BLM threshold increase for TOTEM roman pots

Changes requested

- Where:

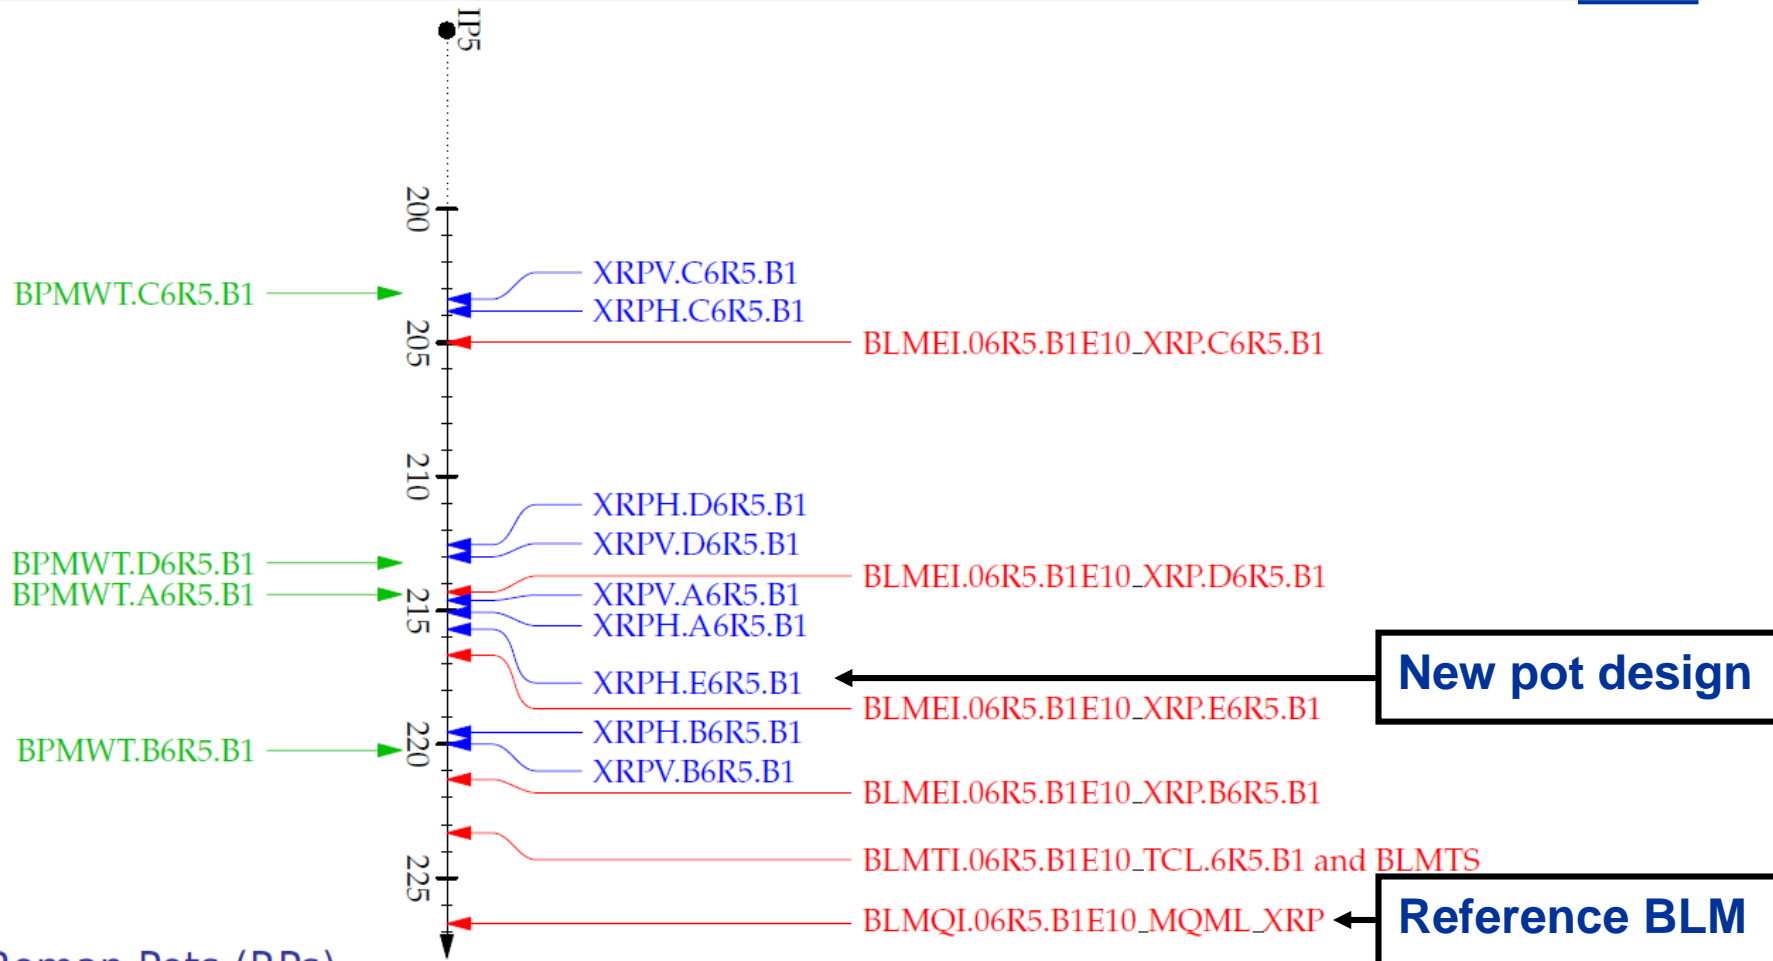
- Only the special TOTEM BLMs “_XRP”
 - 8 BLMs
 - No ALFA BLMs
 - No BLMs which are used for the protection of machine components (magnets, collimators etc.)

- Applied thresholds 20 on _XRP monitors 20 time higher than on the MQML monitor (BLMQI.06R5.B1E10_MQML_XRP) for RS9 (1.3 sec) and longer
- MF unchanged 0.3 (margin for increase)
- Based on the TOTEM analysis (see spare slides).

Change at 6.5 TeV

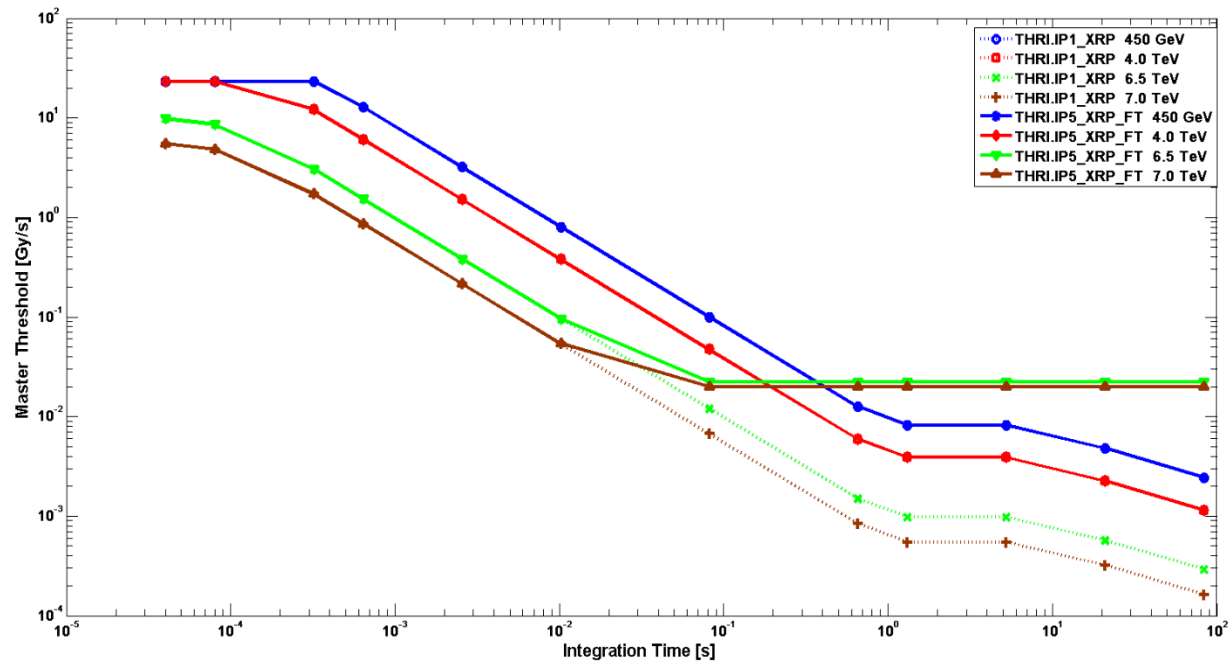
Lower energy thresholds unchanged

Threshold increase factors:

Old / new for 4 energy levels:
